**Re: Clear River Energy Center MTBE Issue Review**

At your request, CDR Maguire and Sovereign Consulting Inc. (Sovereign) has provided a review of the issues related to the use of the Pascoag Utility District Water and disposal of waste process water at the Burrillville Sewer Treatment Facility.

**FIGURE 1 - Location of Pascoag and Harrisville Municipal Wells**

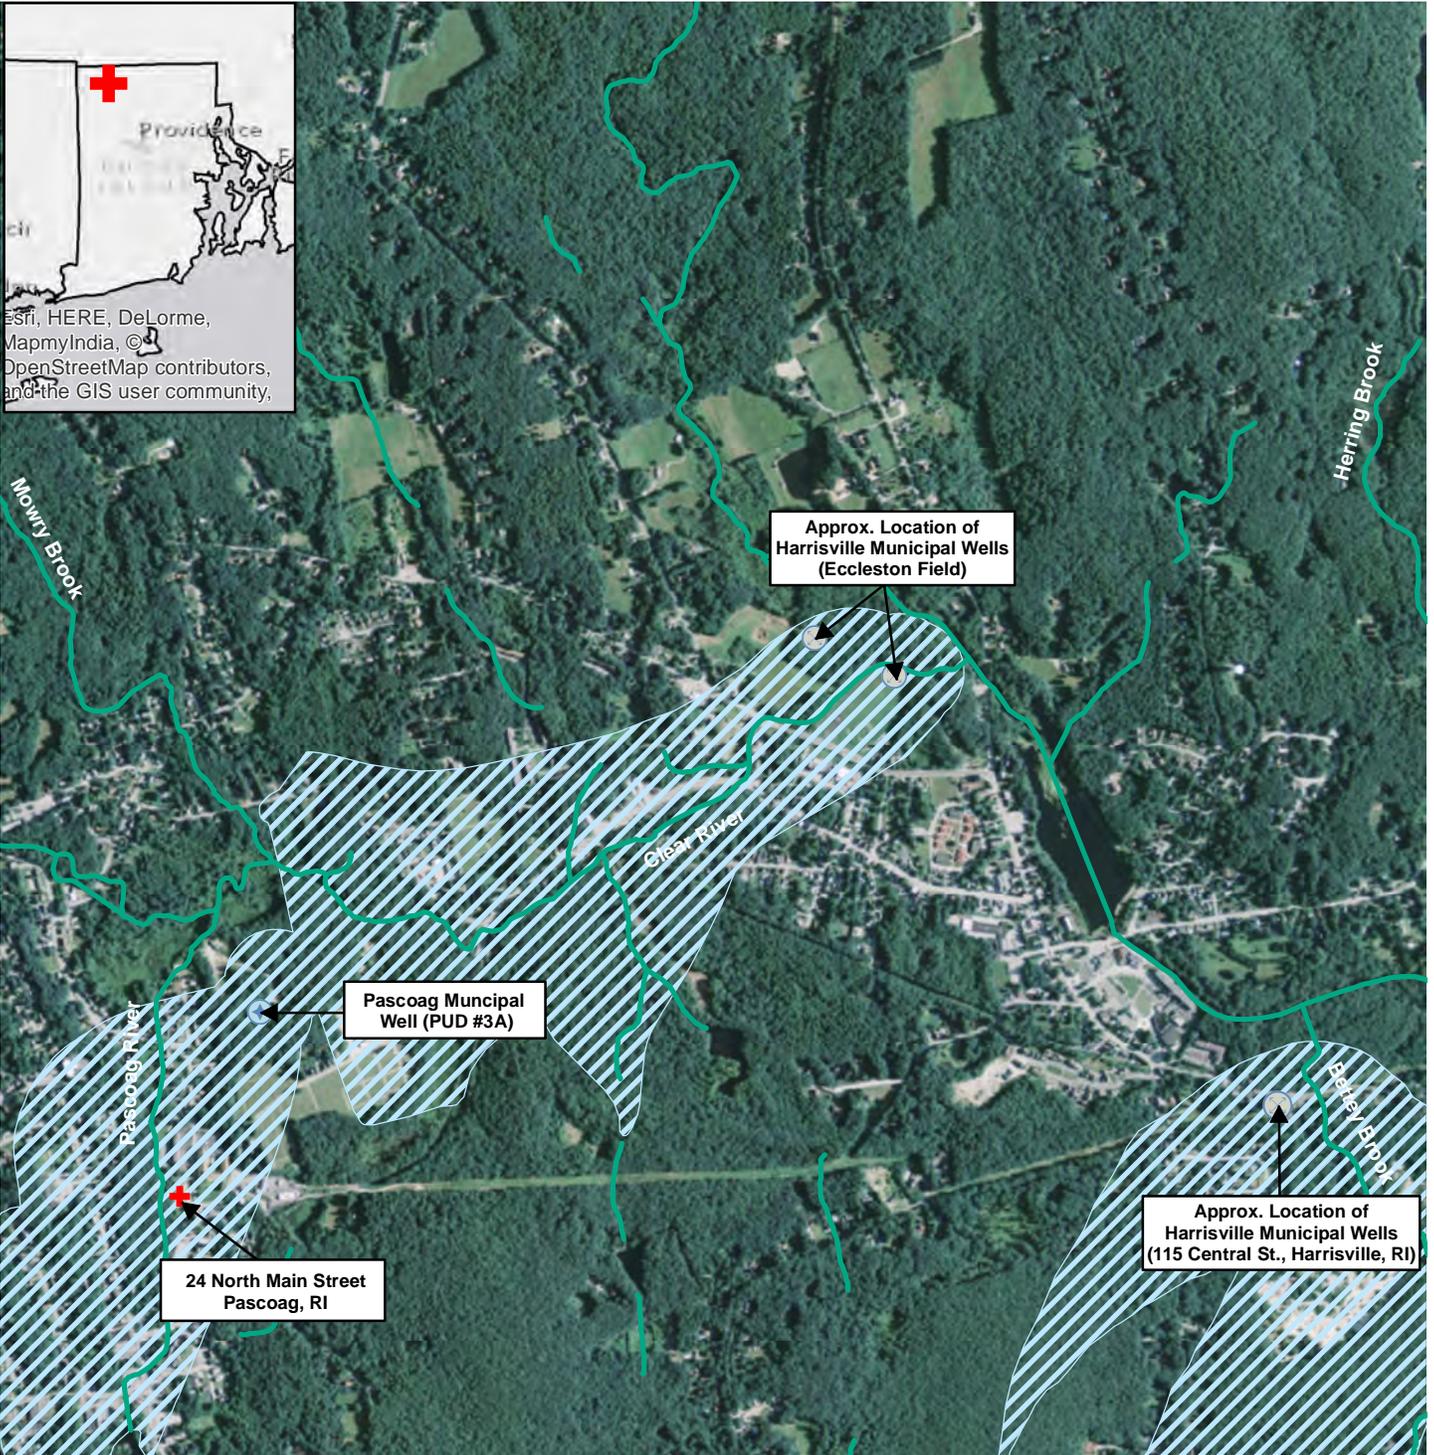
For presentation purposes, **Figure 1** presents the location of Pascoag Well #3A and the Harrisville Utility District production wells. **Figure 2** presents the location of the Interim Wellhead Protection Areas (IWPA's). Even though there is an apparent overlap between the IWPA's of Pascoag Well #3A and the Harrisville Eccleston production field, available information indicates that the Clear River represents an apparent boundary condition that prevents the hydraulic connection and potential contaminant transport between the two IWPA's. This condition should be confirmed as part of the evaluation process for the proposed CREC.

We recommend that Invenergy confirm that there is no hydraulic connection between the Pascoag and Harrisville Utility Districts.

- It should be confirmed that there is not a hydraulic connection between the water sources for the Pascoag and Harrisville Utility Districts. In the event that the CREC project does not proceed, it would be beneficial to demonstrate that the residual contamination related to the petroleum release in Pascoag will not impact the water supply sources in Harrisville. The Harrisville Utility District is currently providing 85% of the water for the Pascoag Utility District.

**FIGURE 6A**  
 APPROXIMATE AREA ABOVE RIDEEM GA  
 GROUNDWATER OBJECTIVES 2002  
 PASCOAG, RI

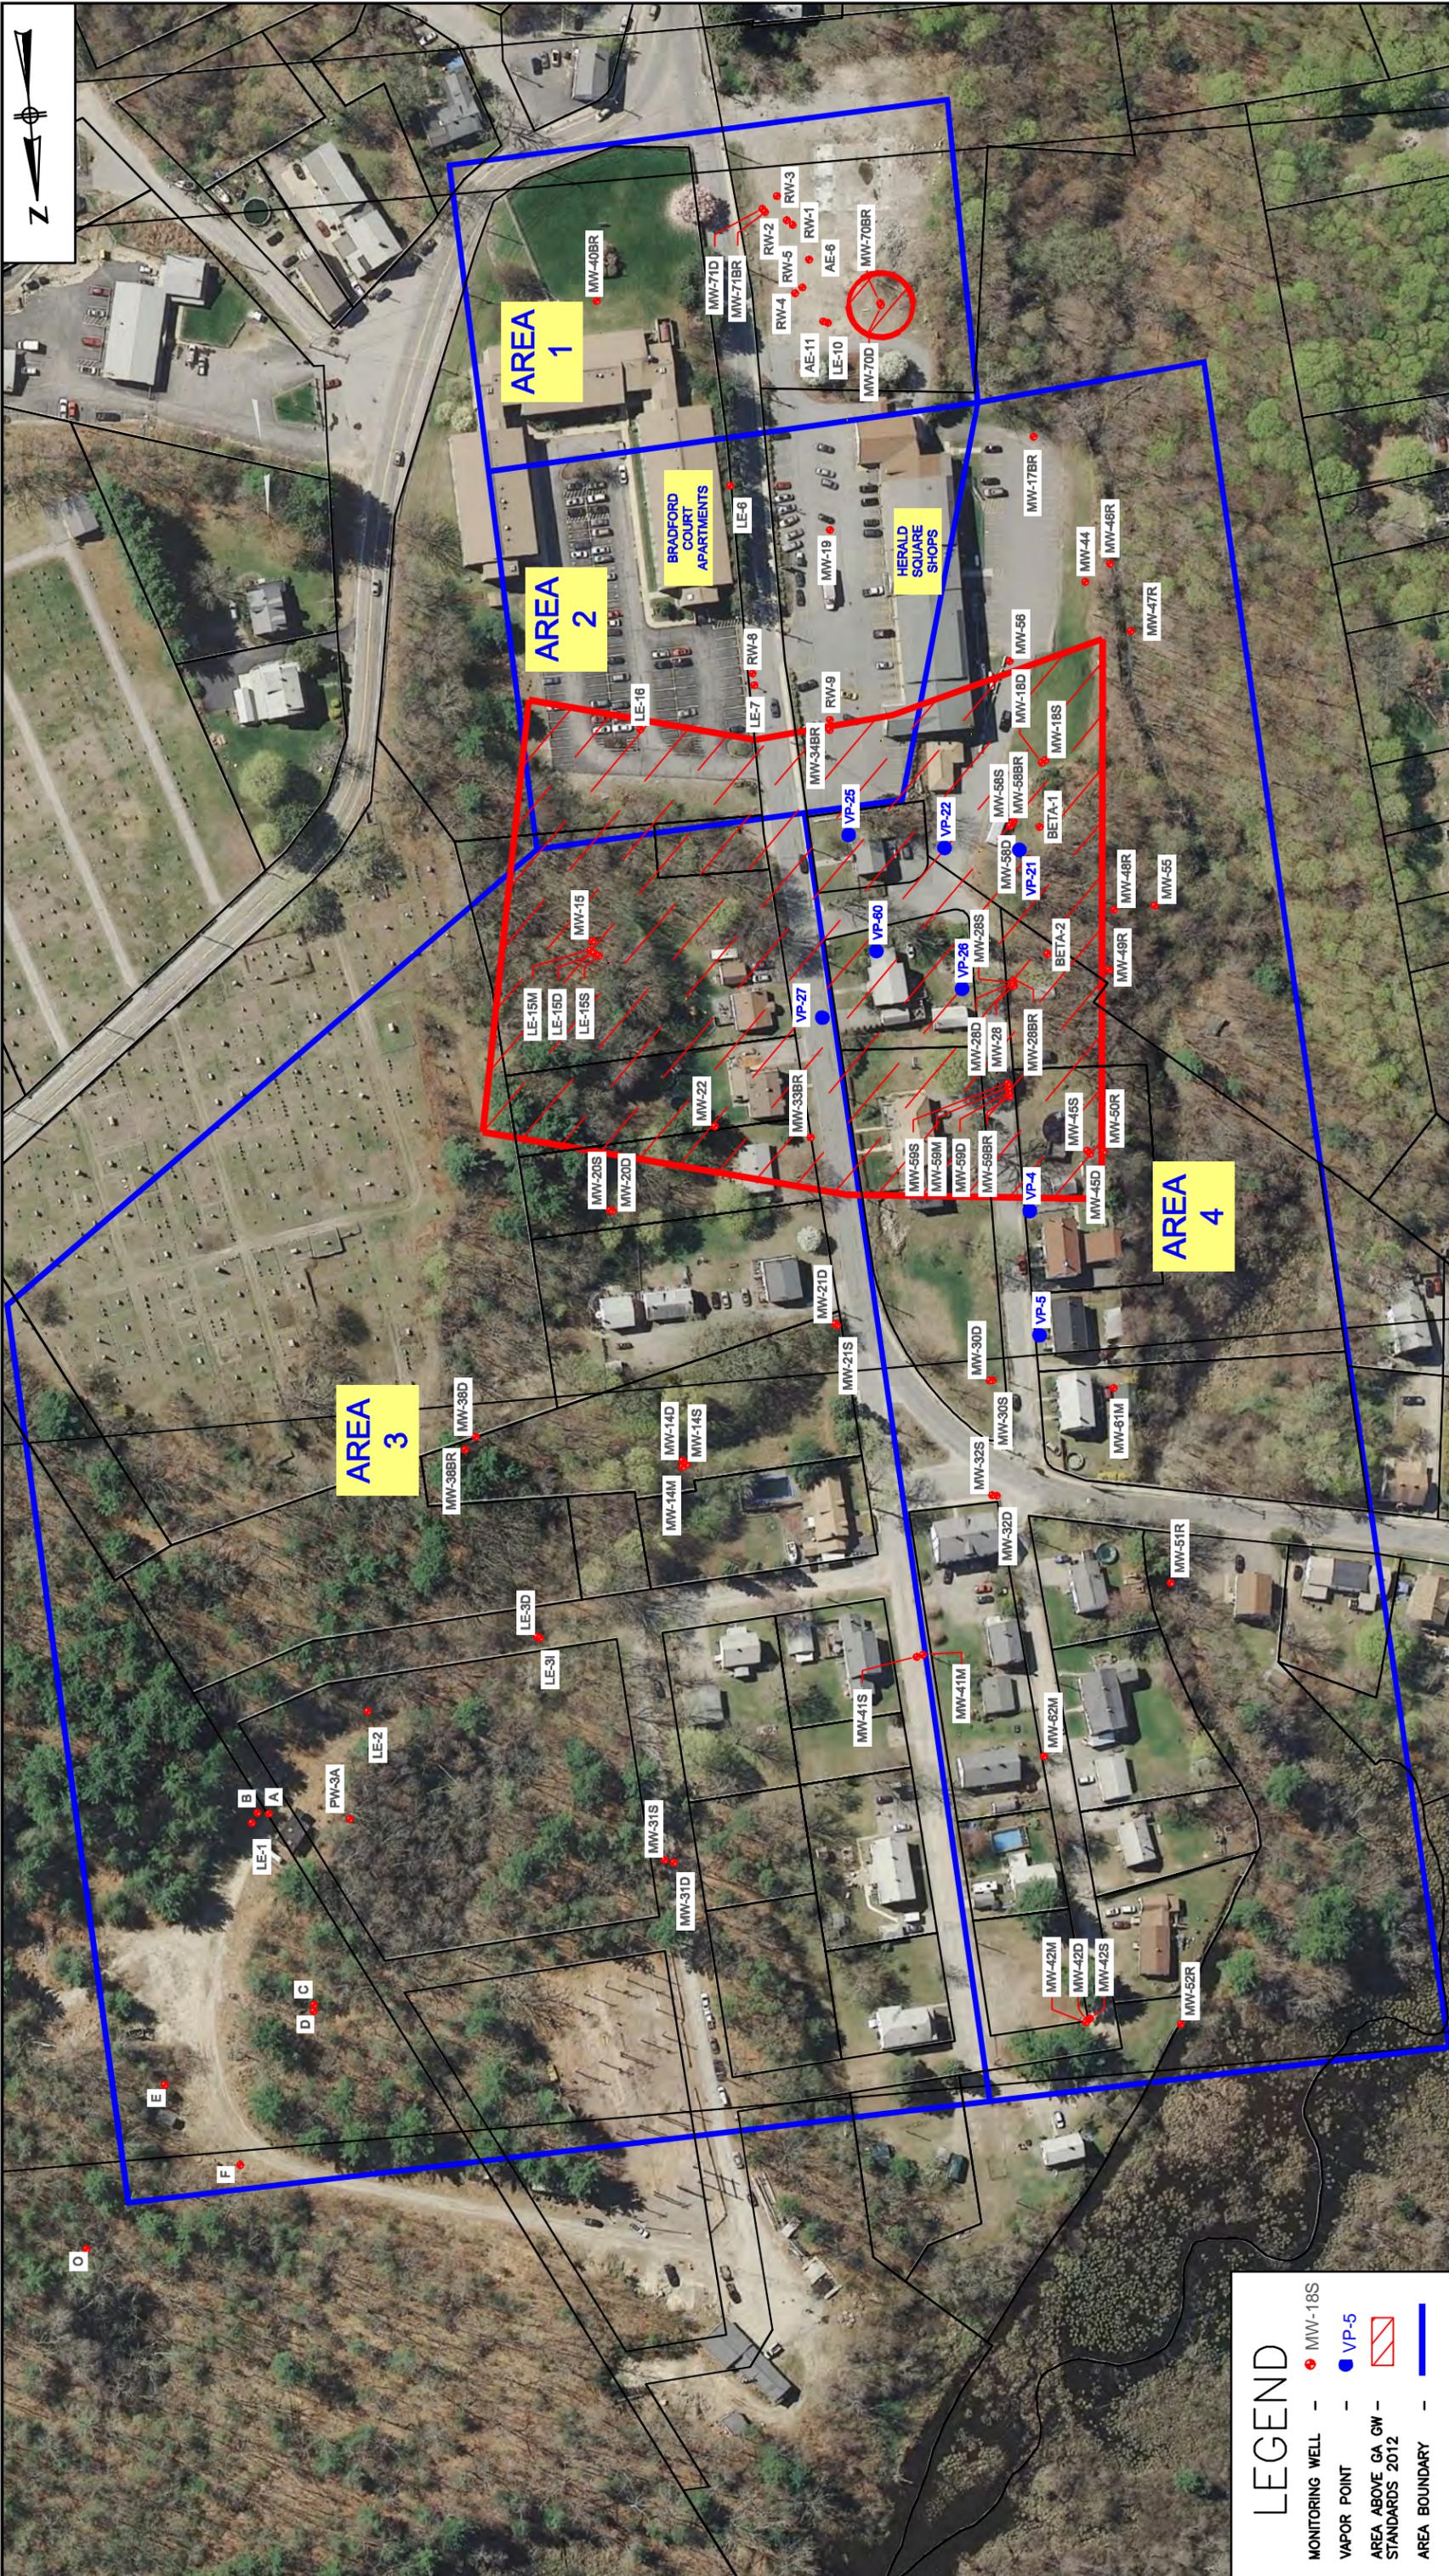
As depicted on Figures 6A, 6B and 6C of the 2013 *Groundwater Remediation Project Summary Report, Pascoag, Rhode Island* prepared by BETA Group, since PUD Well #3A was shut down, and no longer influences groundwater flow direction, the area of groundwater impact has receded. Reactivating PUD Well #3A, will not necessarily impact “new” areas, but might result in the re-expansion of the current VOC impacted plume. In addition, any residual petroleum impacted areas may migrate under the influence of the reactivation of PUD Well #3A.
